**PR/0695/22**

## Record of Executive Business and Chief Executive's Order

<b>Reg. Reference:</b>	SD21A/0350	<b>Application Date:</b>	21-Dec-2021
<b>Submission Type:</b>	Additional Information	<b>Registration Date:</b>	06-May-2022
<b>Correspondence Name and Address:</b>	Michael Malone, Ceardean Architects 9, Dolphins Barn, Dublin 8		
<b>Proposed Development:</b>	Retention of constructed fence and boundaries and the relocation of existing access gate to revised location and proposed use of space as an allotment.		
<b>Location:</b>	Long Mile Road, Drimnagh, Dublin 12		
<b>Applicant Name:</b>	Noel Whelan		
<b>Application Type:</b>	Permission and Retention

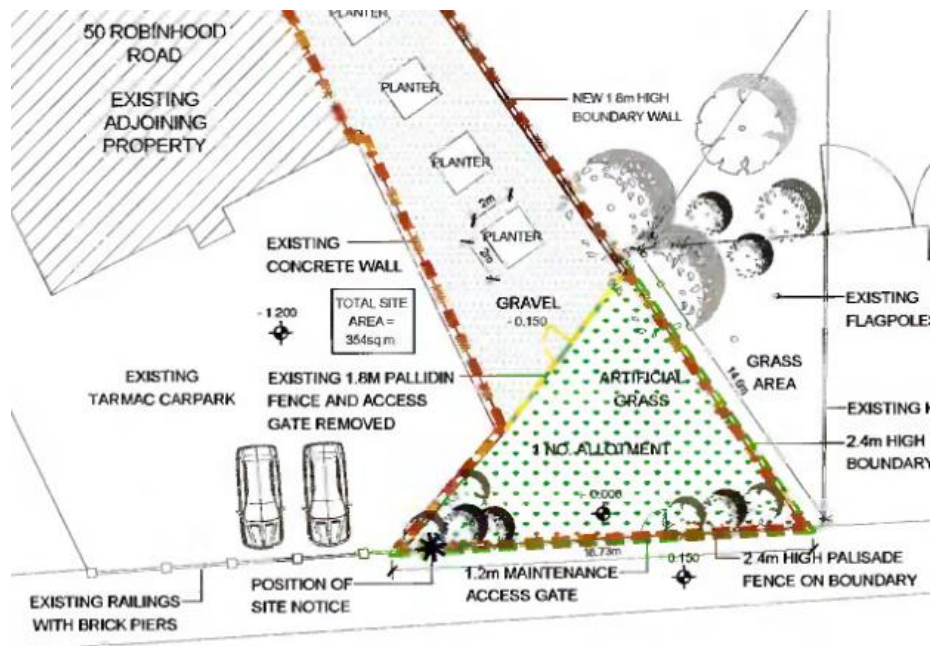
It is also noted that the proposed security fence extends well beyond the established building line and meets the public footpath. In this regard the development would be contrary to section 11.2.5 and Table 11.18 of the County Development Plan, which seeks a landscaped parkland type setting for new development in areas such as this.

The Site Block Plan and Contextual Elevation drawing submitted also **proposes** the construction of a new 1.8 m high boundary wall on the eastern side of the subject site. Please see extract from drawing below. This is not clear in the description of works.

### ***Additional Information Requested by SDCC:***

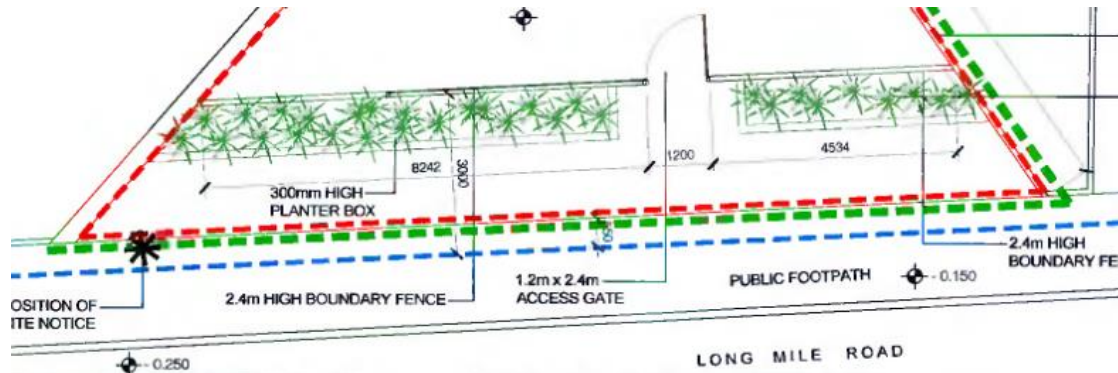
The applicant is therefore requested to submit comprehensive information on the recent history of the site including details as to how long it has been operating as a single site, and show if this use situation is authorised. It is considered this may be dealt with by way of additional information.
